### APPEAL SUMMARY

**Appeal ID:** 20223

**Building/Business Name:** Cruzan Slabtown Office Building **Fire Sprinklers:** Yes - Throughout

## APPEAL DECISION

FIRE SPRINKLER  
 STANDPIPE PLANS -  
 STAIR 1 SOUTH

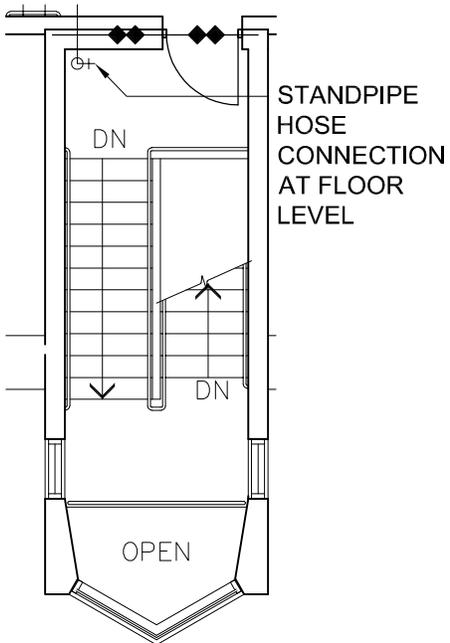
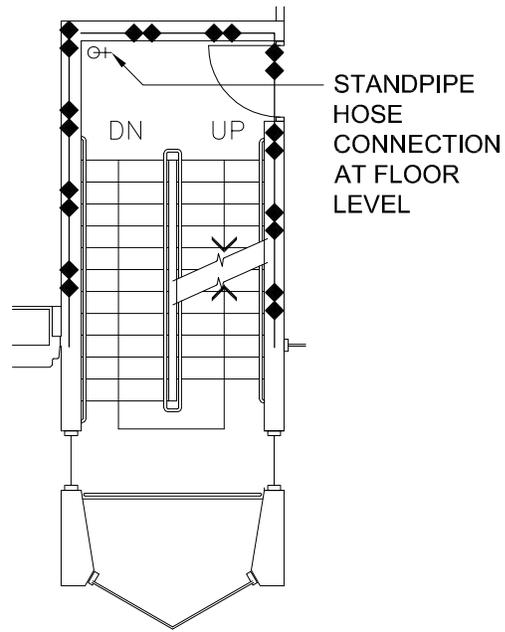
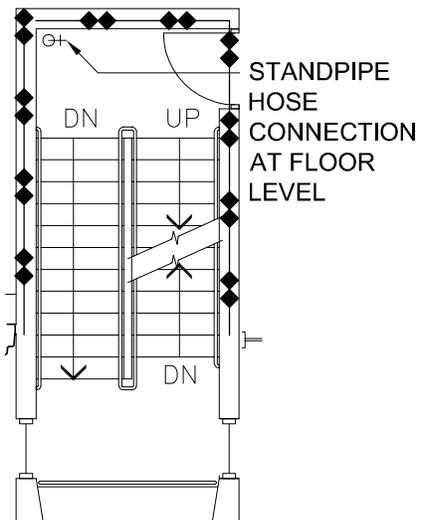
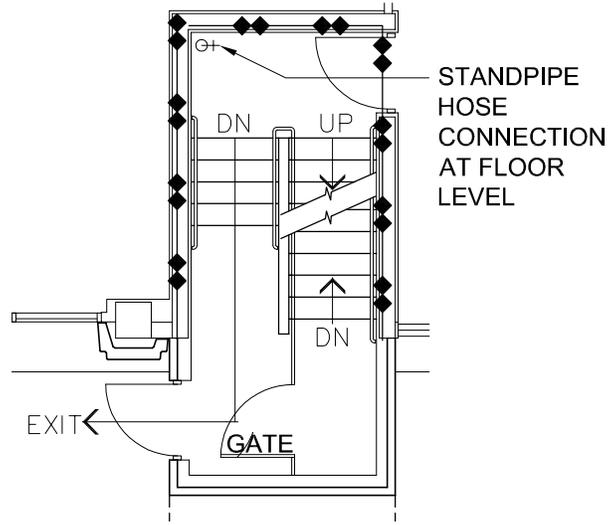
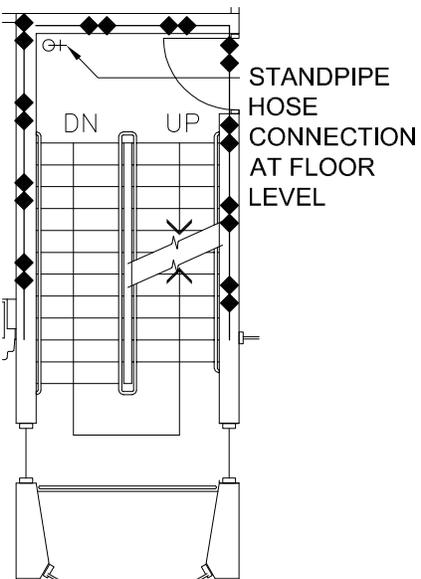
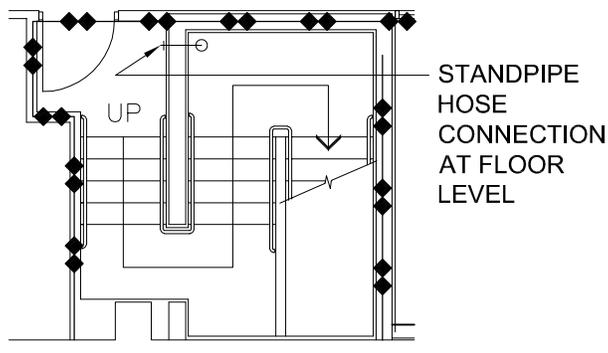
**Code Section** 905.4 Standpipe Hose connection locations

**Requires** Required hose connections shall be located at an intermediate floor level landing between floors unless otherwise approved by the fire code official.

**Proposed Design** The existing building was built under the 1985 UBC which allowed for standpipes to be located at floor level landings.

Exhibits 1, 2, 3 and 4 show the existing standpipe locations. As part of a separate appeal (ID 20102) to adopt the 2014 OSSC as the applicable building code for current and future permits in this building, non-compliant conditions are being remediated or appealed. This is one condition that is desired to be appealed to leave as-is.

**Reason for alternative** The hose connections are provided for in the stairways as required by the code for which the building was originally permitted.

(It is our understanding that the 2019 OSSC may revert to the floor landing location once again). However, in the meantime, we propose to upgrade the sprinkler system in other ways such as replacing the heads to quick response type and updating the alarm and detections systems in the building to provide greater life safety and fire protection.

We respectfully request that the existing location of standpipe hose connections be allowed to remain as-is by granting this appeal.

- 1. Location of standpipe hose connections at floor level landings: Granted as proposed.**
- 2. Exterior exit door not readily visible from point of exit enclosure termination: Granted as proposed.**

ENLARGED GROUND  
 FLOOR EXITING PLAN  
 PROPOSED  
 CONDITIONS

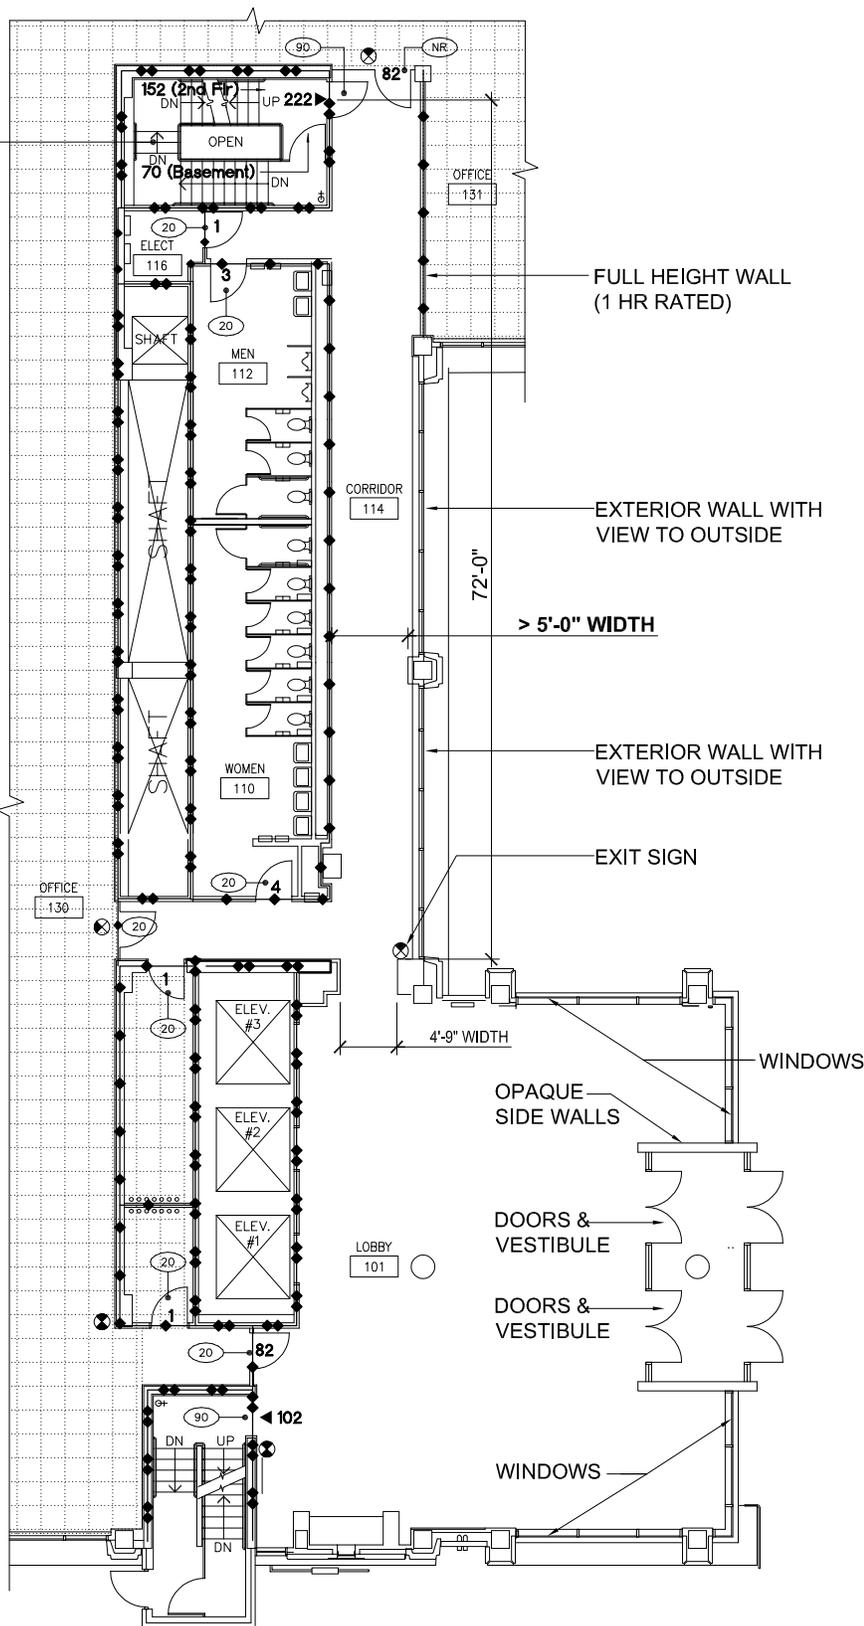
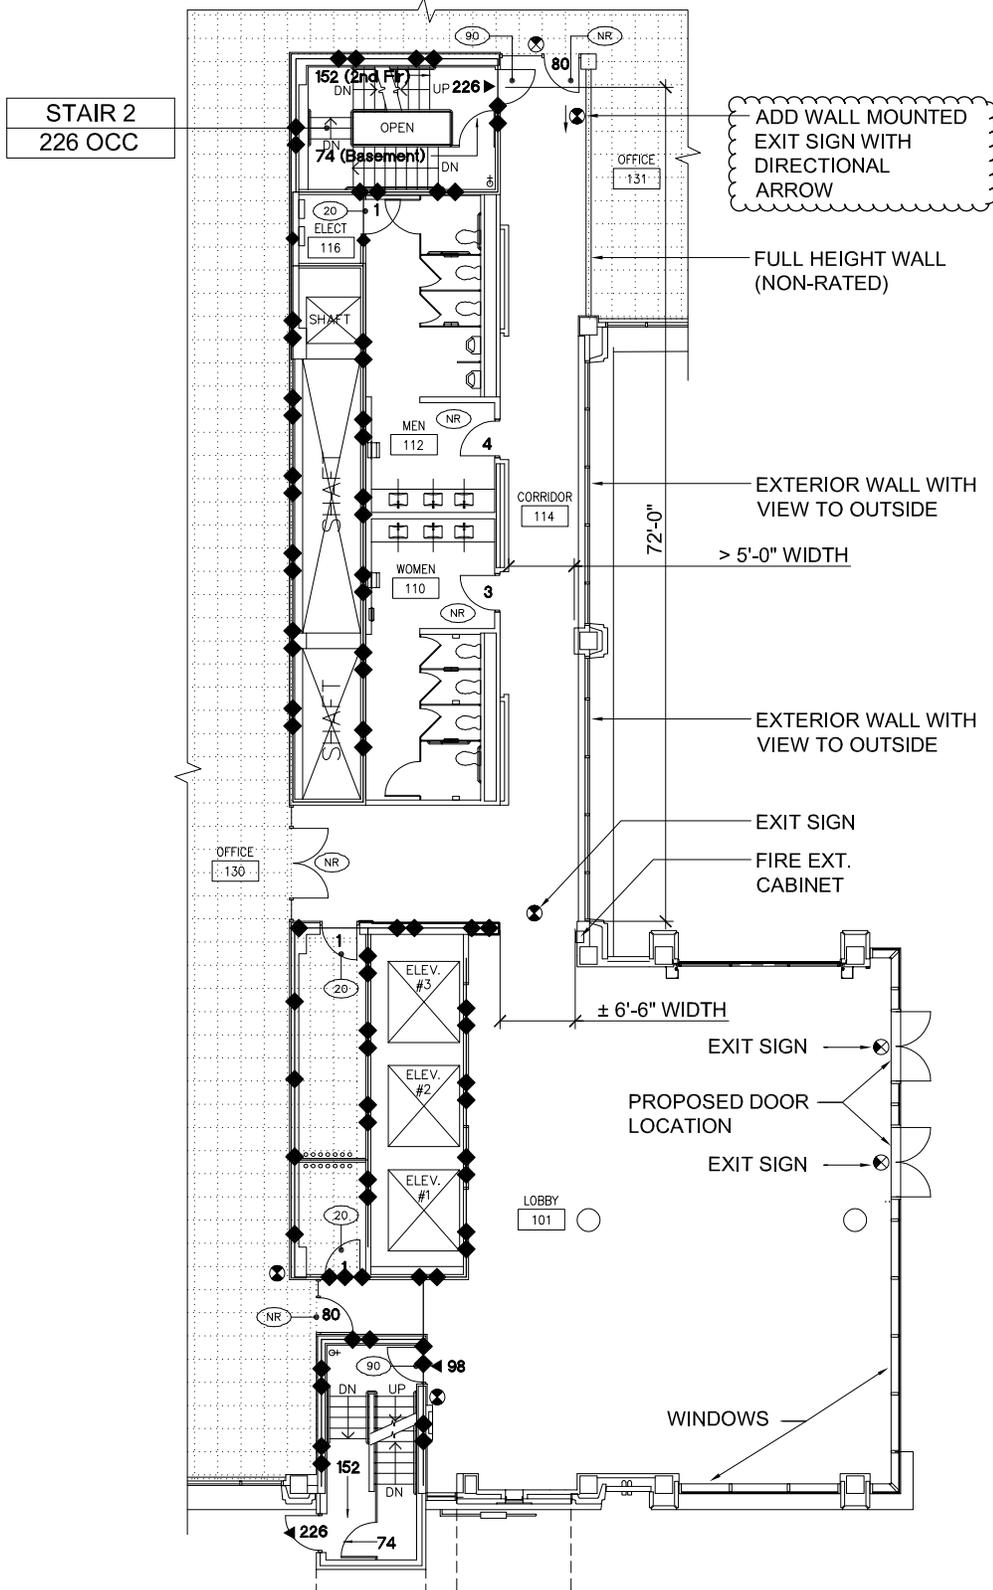
<b>Code Section</b>	2014 OSSC Sec.1027.1 Exit Discharge, Exception 1.1
<b>Requires</b>	<p>Maximum of 50% of the number and capacity of interior exit stairways is permitted to egress through areas on the level of exit discharge provided all of the following are met:</p> <p>1.1 Such enclosures egress to a free and unobstructed path of travel to an exterior exit door and such exit is readily visible and identifiable from the point of termination of the enclosure.</p> <p>1.2 Entire level of discharge is separated from the level below by 2hr rated construction- COMPLIANT</p> <p>1.3 Entire level of exit discharge is protected with an automatic sprinkler system.- WILL COMPLY.</p>
<b>Proposed Design</b>	<p>The existing building was built under the 1985 UBC which allowed for an exit to pass thru a lobby with the only stipulations being that the required exit width must be free and unobstructed, and the entire street floor must be protected with an automatic sprinkler system.</p> <p>One of the two enclosed stairways (Stair 2) exits at the ground floor into a corridor that extends to the main lobby. The path of travel is free and unobstructed, but the exit is not immediately visible from the termination of the stair enclosure. The corridor extends essentially in one direction, towards the lobby, and within a short distance, windows along the east edge of the corridor that provide glimpses of the lobby beyond and help to direct people towards the exit. Additionally, we proposed to add illuminated exit signage on the wall opposite the stair door to provide immediate direction toward the lobby for people exiting the stair.</p> <p>For reference, a separate appeal (ID 20102) is under review to adopt the 2014 OSSC as the applicable building code for current and future permits in this building. A code comparison, and schedule of code deficiencies and proposed upgrades is shown in Exhibit A. Proposed upgrades include replacing sprinkler heads with quick response type, new fire alarm panel, and updated detection and notification systems.</p> <p>The existing corridor's construction appears to be 1 hour rated. Current code section 1018.1 allows for non-rated corridors.</p> <p>Exhibits 1 and 2 show the exiting plans for the existing ground floor. Exhibit 3 shows the proposed exiting to reflect planned modifications of the core restrooms and corridor wall ratings and lobby door locations, as well as the previously noted enhanced exit signage.</p>

<b>Reason for alternative</b>	<p>The additional exit signage will provide the immediate direction to those occupants exiting the stair. The corridor extends only in the direction of the lobby so it should be fairly obvious which direction to go.</p> <p>The opening from the corridor into the lobby is proposed to be widened, as much as possible, to also minimize any bottlenecks to the exit.</p> <p>The lobby vestibule is planned to be removed and the doors shifted closer to the exit path to clearly differentiate the circulation areas from other lobby functions like seating areas.</p> <p>Along with the other proposed upgrades to the sprinkler system, alarm, detection and notification systems a greater degree of life safety will be achieved.</p> <p>We respectfully request that this appeal be granted.</p>
